## CHAPTER B.

### EVALUATION REPORTS AND CROSS SECTIONS

**1. Virginia By Products Division of Knox Creek  
Permit 1100321**

SECTION H

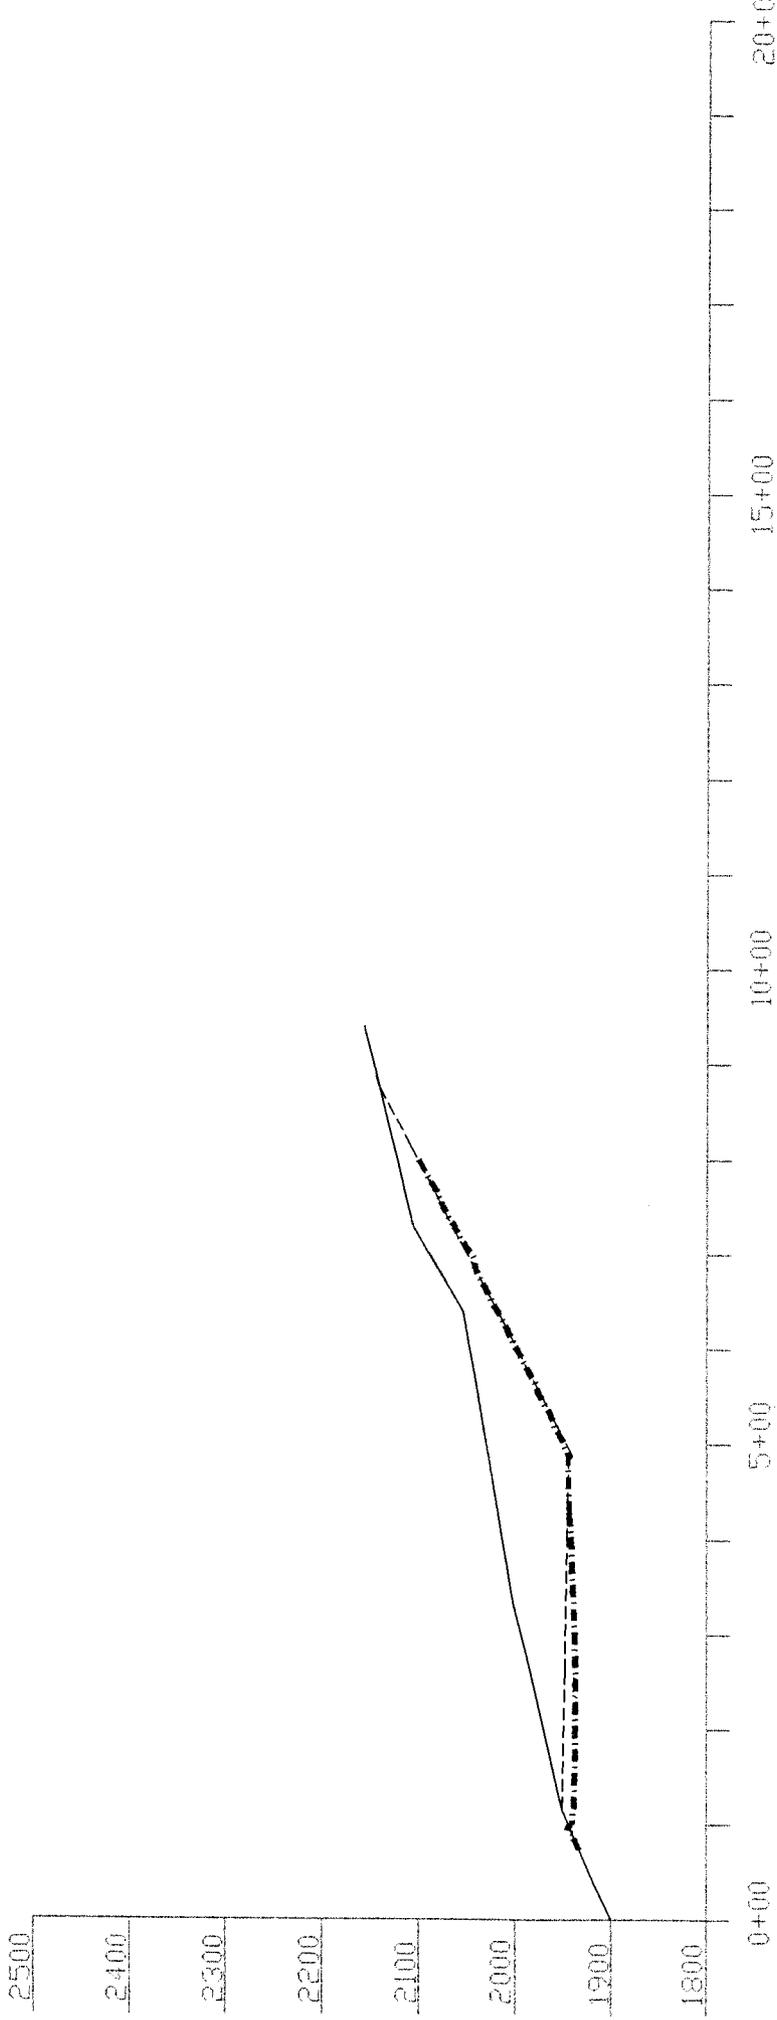
**Approximate Original Contour:** A variance from AOC restoration was approved by Virginia DMME/DMLR for part of the permit area. The highwall was completely eliminated in the regrading. Field observations did not identify any major changes in the original drainage patterns.

SECTION 2--2

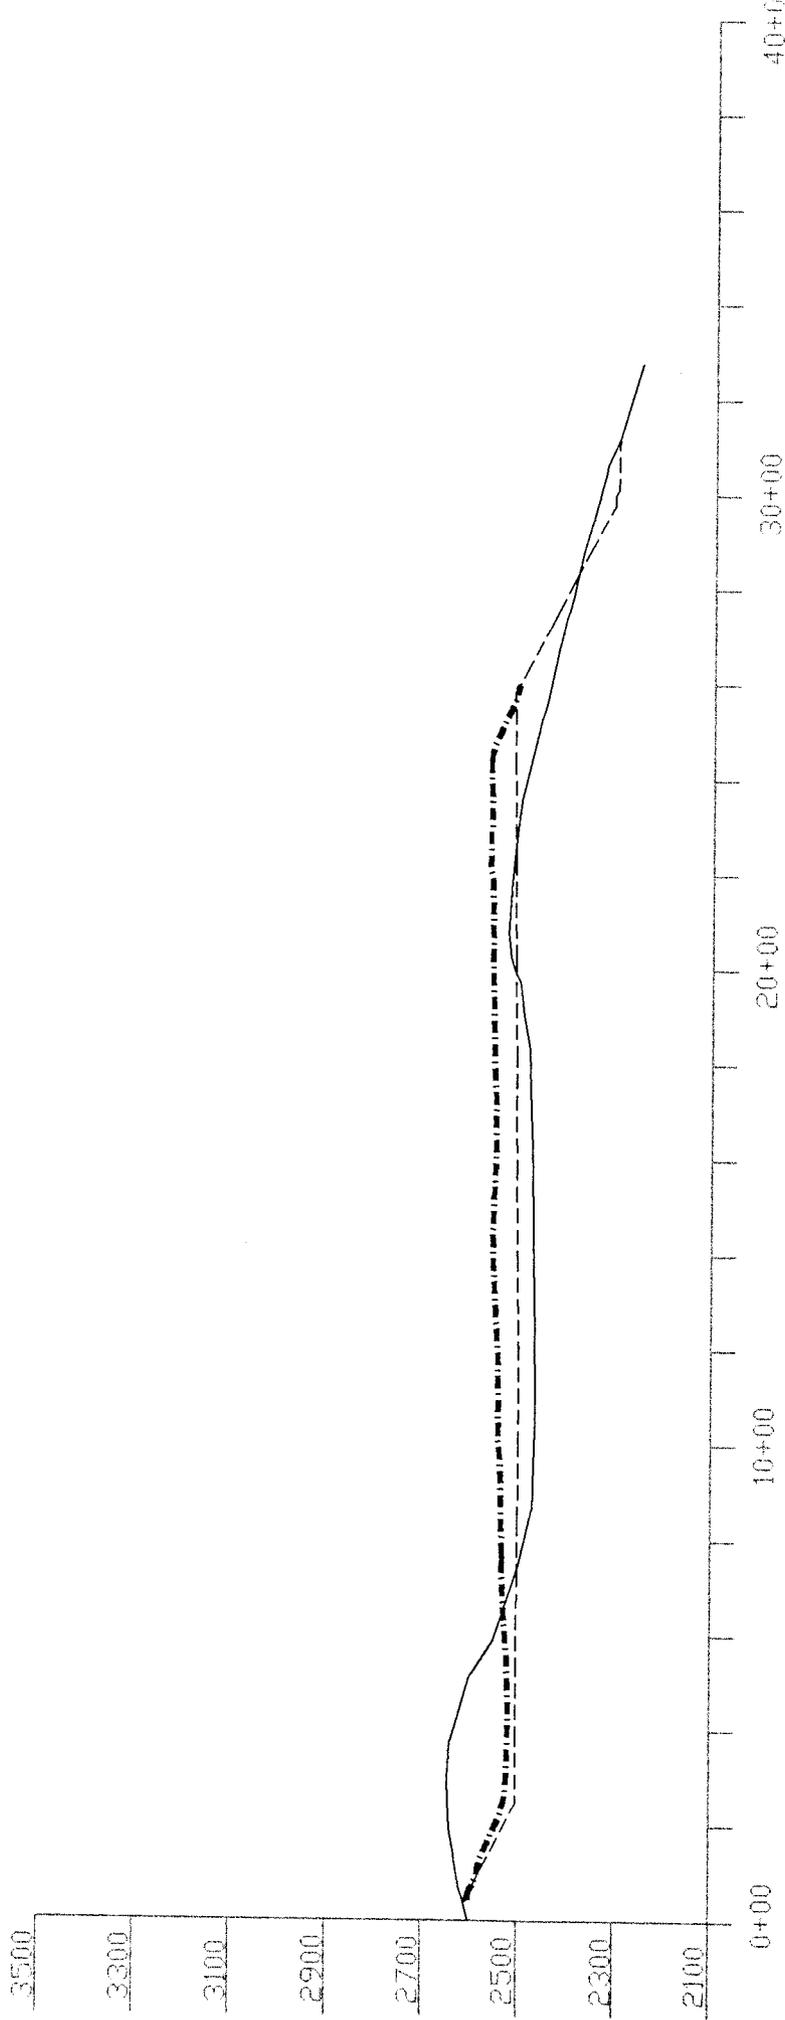
**Approximate Original Contour:** The permit narrative requests the mountaintop removal variance in the vicinity of cross section 2-2 and 4-4. These sections identify removal of approximately 150 feet of overburden with a regrade line gently sloped inward to an outlet drainage ditch, to create useable flat land for the postmining land use. The rest of the permit will be reclaimed to AOC. The GPS field cross sections 2-2 and 4-4 conformed closely to the original proposed cross section in the permit package on the AOC variance area. The final regraded land form is approximately 35' higher than proposed regraded land form with out-slopes still consistent with approved plans. All mining is completed along sections 2-2 and 4-4. The GPS survey showed maximum elevation changes of -110 feet with an average change of +35 feet. Field observation did not identify major changes to drainage patterns.

SECTION C-C

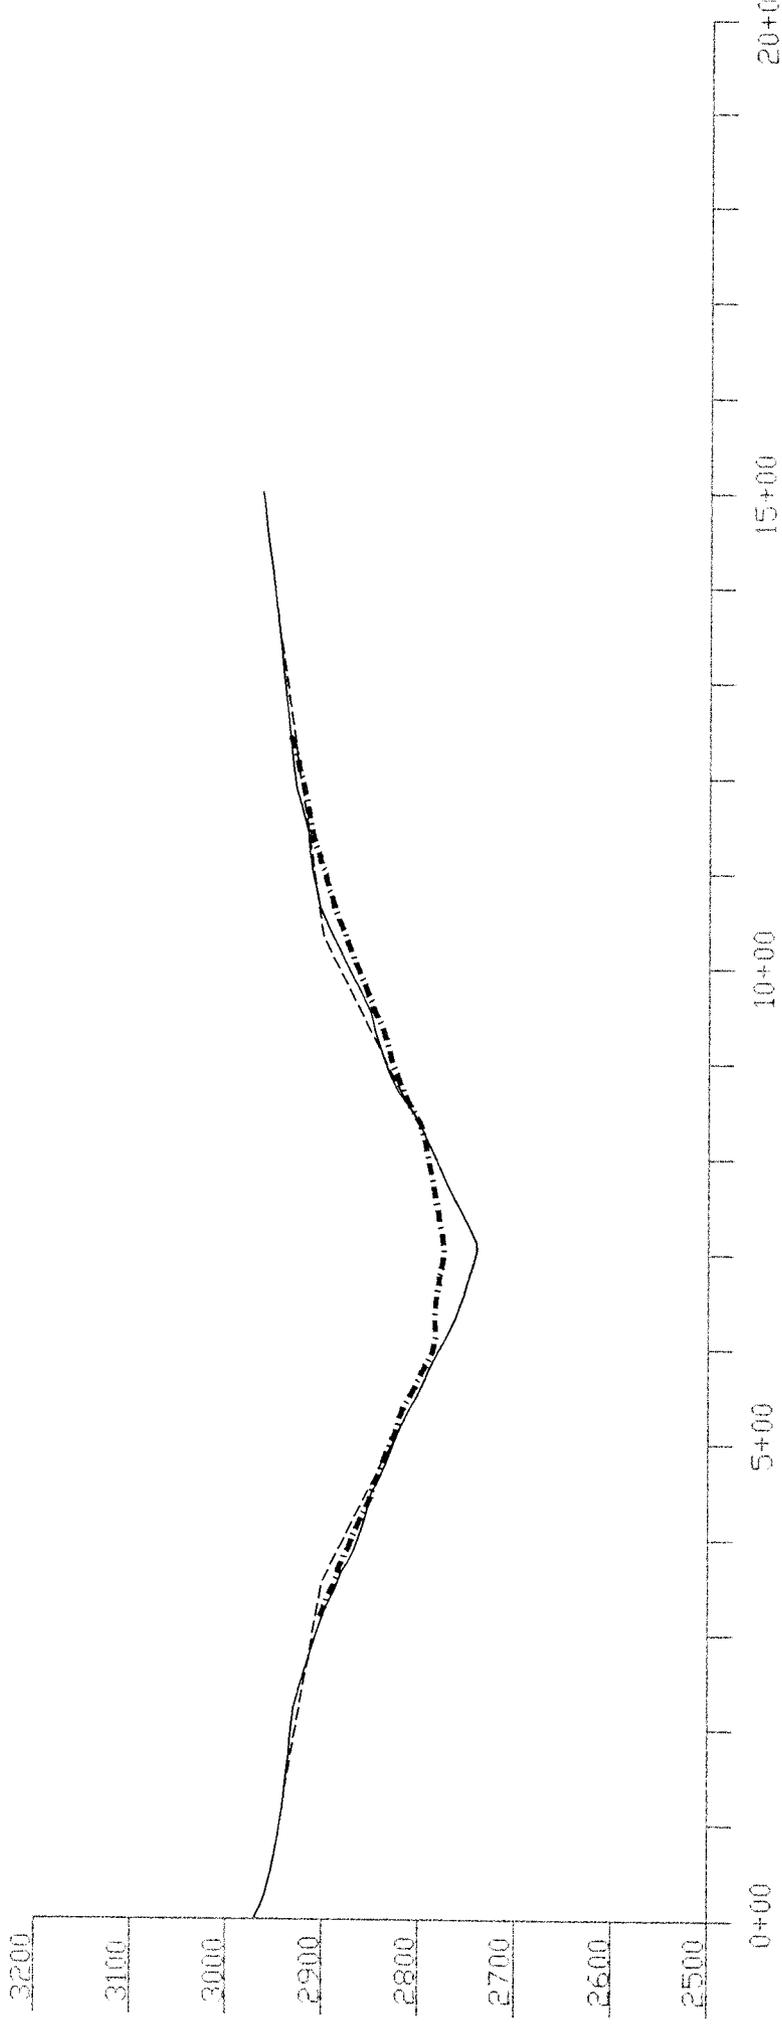
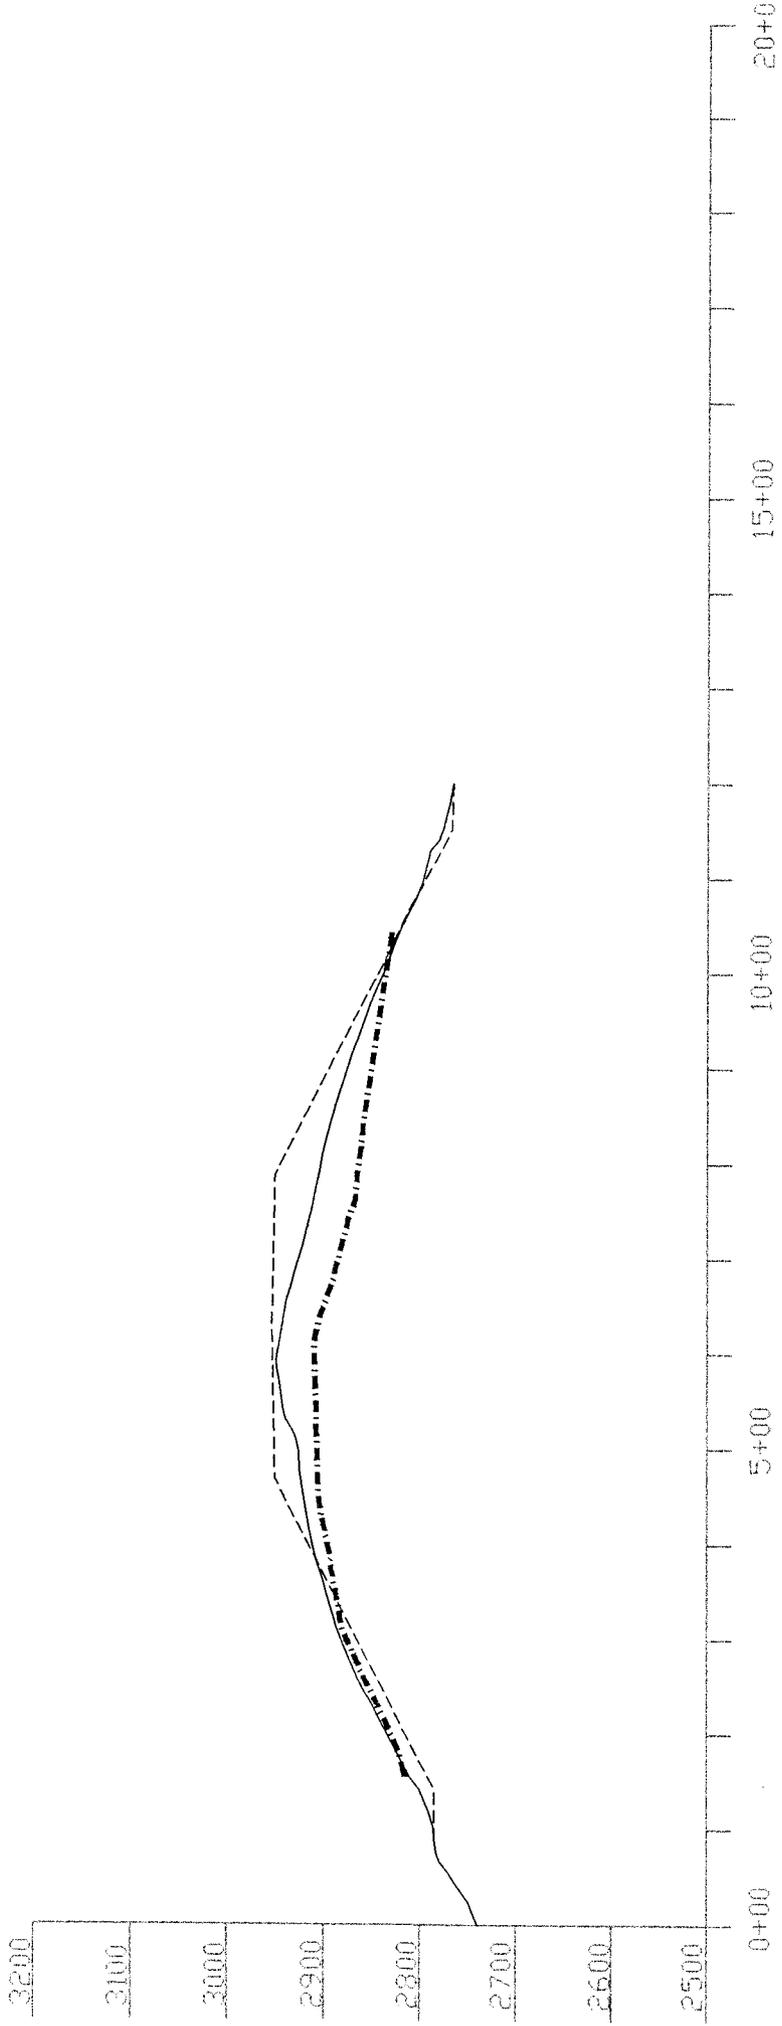
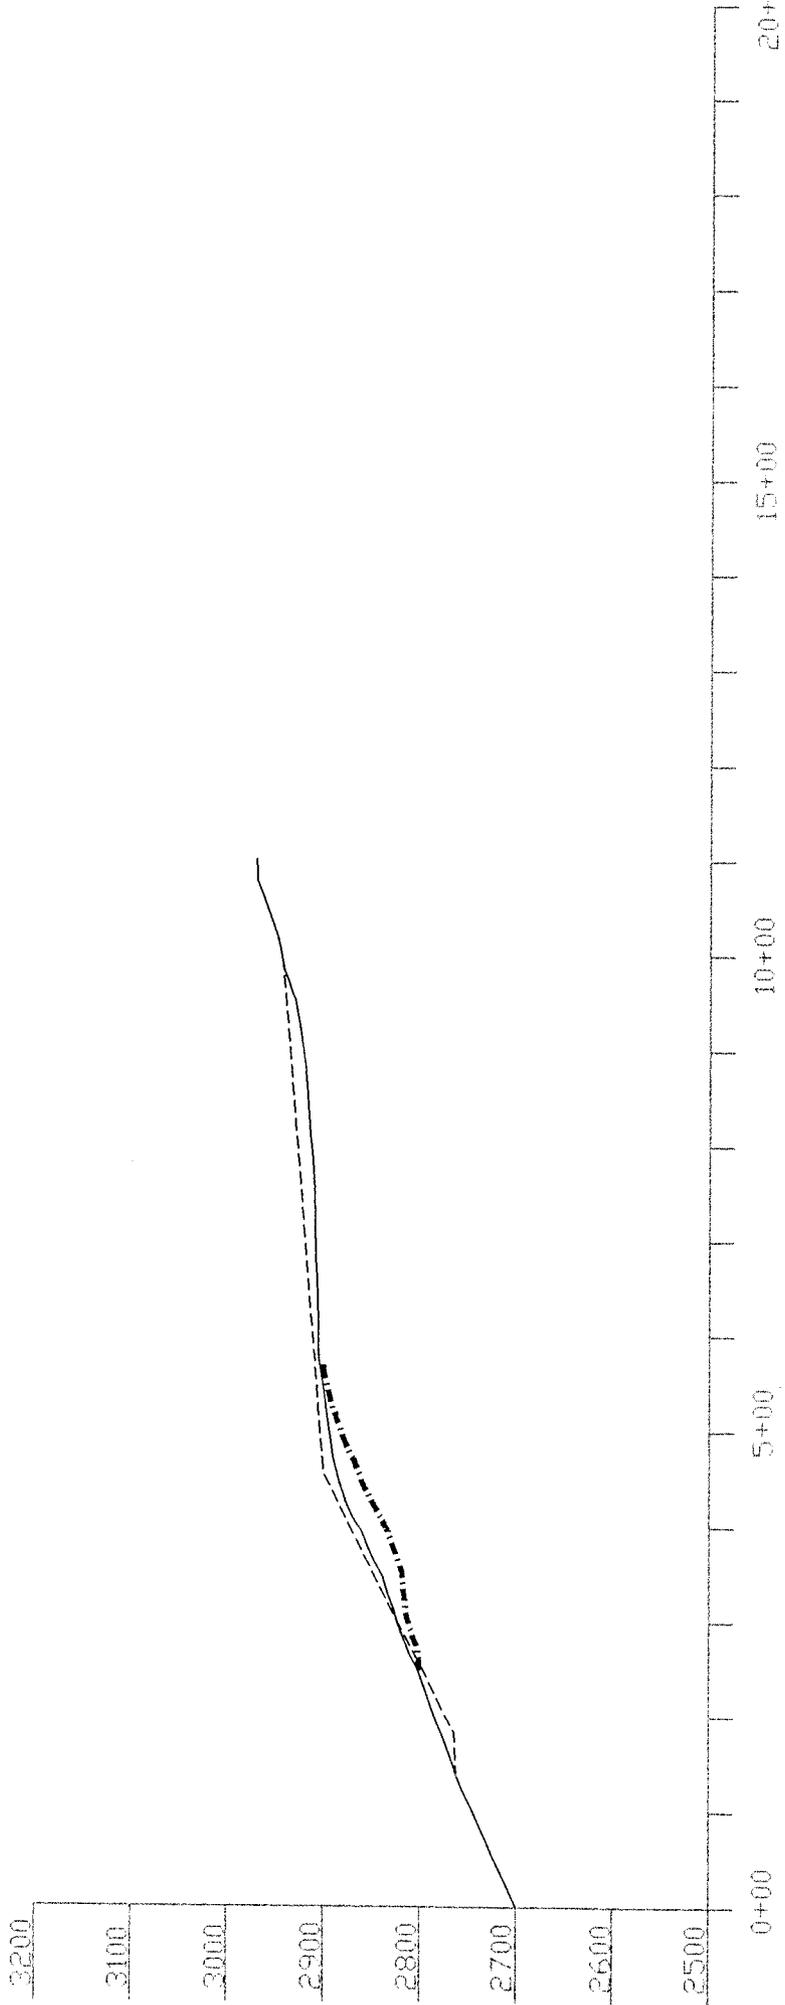
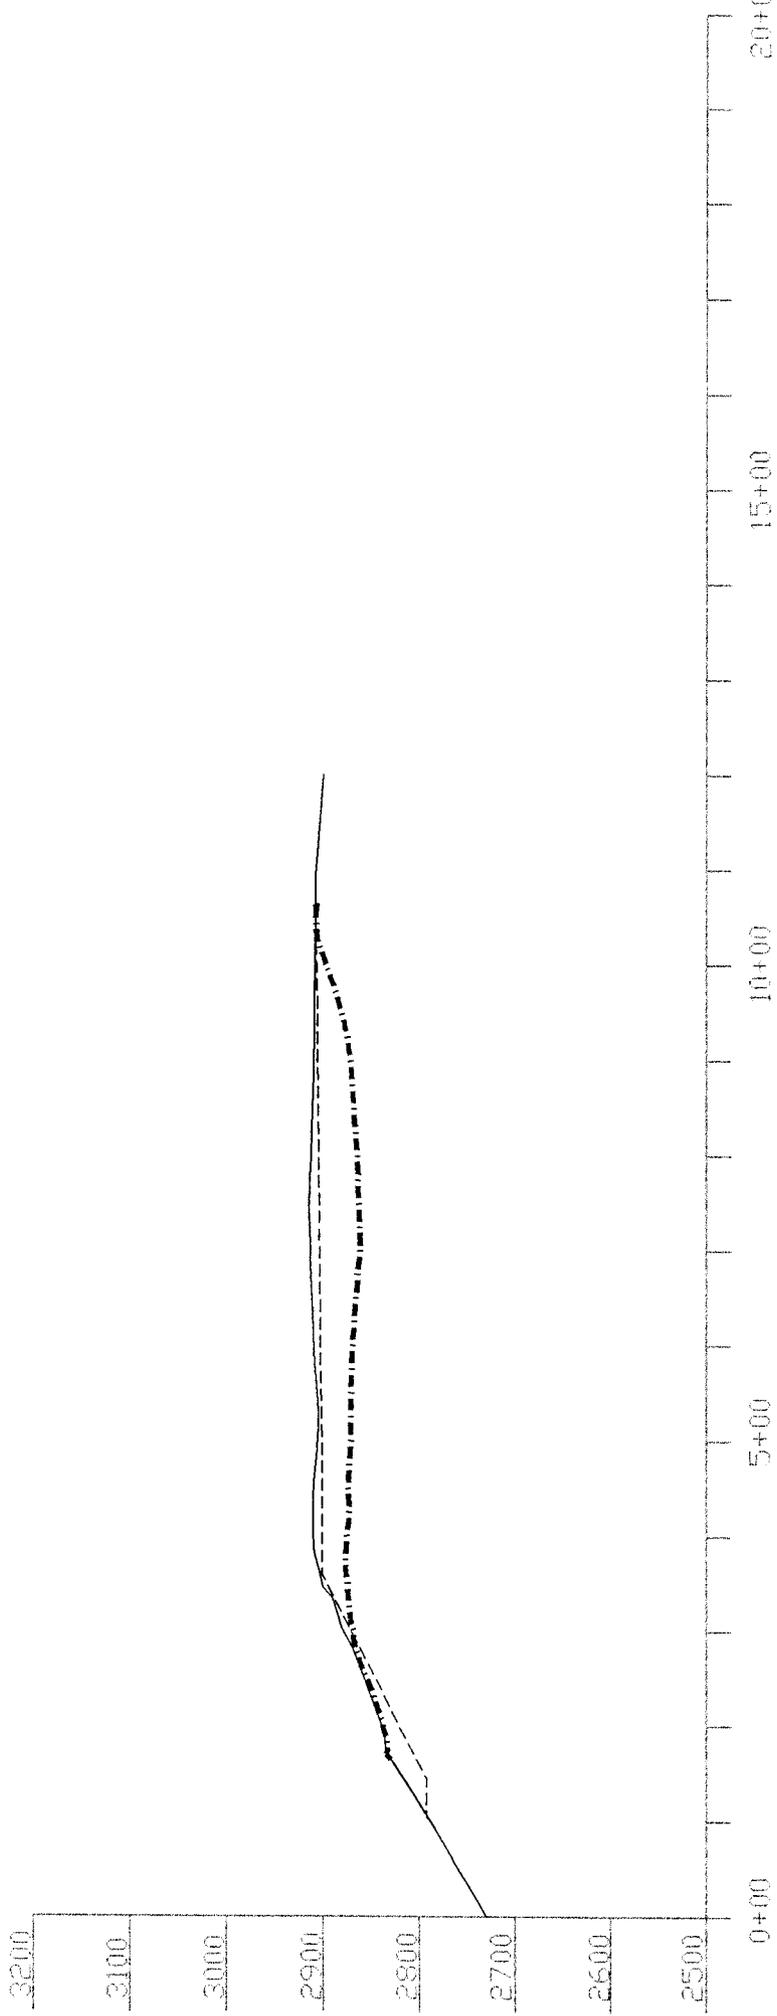
**Approximate Original Contour:** The proposed backfill was similar to the premining configuration. In one area the backfill toe was located approximately 275 feet from the outcrop leaving a bench which was not originally present; therefore, less material was placed in this area than was originally present. The backfill toe in another area was located approximately 180 feet from the outcrop and the original ground in this area was gently sloping for approximately 400 feet from the outcrop; therefore, more material was placed in this area than was originally present. On another area the backfill was flat on top instead of rolling and was an average of 16 feet lower in elevation. A GPS survey of the site found a maximum elevation change of -50 feet and an average change of -16 feet. No major changes in drainage patterns was noted.
